UNITED STATES PATENT AND TRADEMARK OFFICE

Office Action Summary

10/675,442

DETAILED ACTION

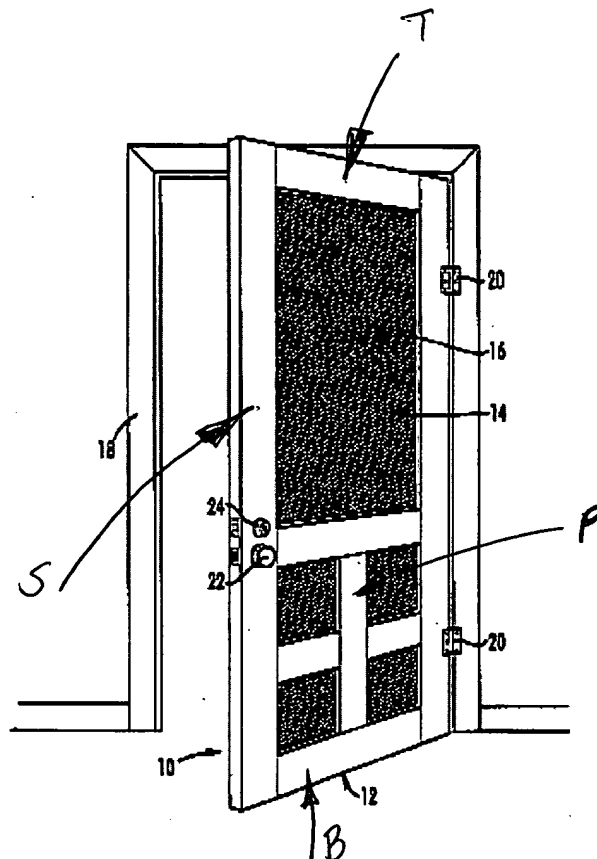
Claims 1-3,5,8 are rejected under 35 U.S.C. 102(b) as being anticipated by US Patent #6,250,040 to GREEN. GREEN discloses the use of a frame assembly (12) including a bottom frame (B), a pair of spaced side frame members (36,38), a top frame (30,32) spaced from the bottom frame (B) and connected to the side frame members (36,38), at least one picket (44) extending between and connected to the top (30,32) frame and bottom (B) frame, and a screen (14) also mounted to the top (30,32),side (36,38), and bottom frame members (B). See below. Regarding claims 2 and 3, the at

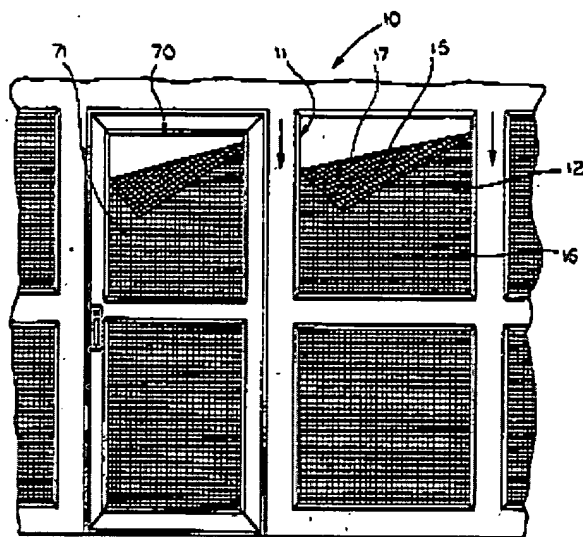
Claim 9 is rejected under 35 U.S.C. 103(a) as being unpatentable over US Patent #6,250,040 to GREEN in view of US Patent #5,046,546 to BENEDYK et al. GREEN discloses the basic claimed frame assembly except for the use of multiple screens. BENEDYK et al. discloses that it is known in the art to provide a frame assembly (10) with multiple screens (12), specifically a separate screen from the top (T) to the middle picket (P) and from the middle picket (P) to the bottom (B2). Although the figure is cut-off, it too would be understood that the screen (12) of BENEDYK et al. includes a separate screen positioned between side members (S) and pickets (P). See below.
